May 29, 2025
PROJECT NAME: MULTI-FAMILY NW 58TH CT
PROJECT NUMBER: 2024040100
APPLICATION: MINOR SITE PLAN #31472

TREES DESCRIPTION

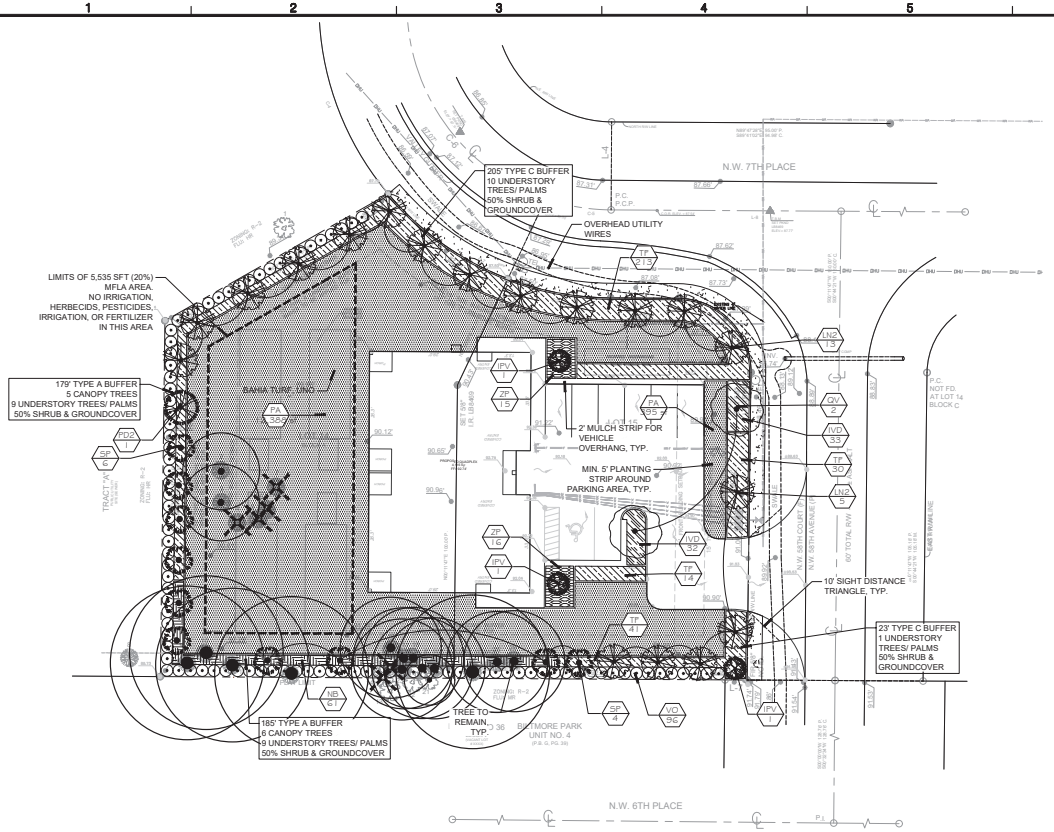
8 DEPARTMENT: LSCAPE - LANDSCAPE DESIGN AND IRRIGATION
REVIEW ITEM: 6.7.6 - Tree removal submittal requirements
STATUS OF REVIEW: NO
REMARKS: revise tree table based on comment about invasive species

7 TREE PROTECTION

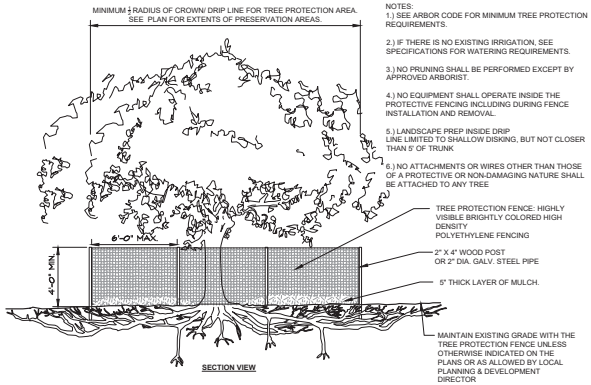
7 DEPARTMENT: LSCAPE - LANDSCAPE DESIGN AND IRRIGATION
REVIEW ITEM: 6.7.3 - Tree protection
STATUS OF REVIEW: NO
REMARKS: show tree protection on plan as well as in detail
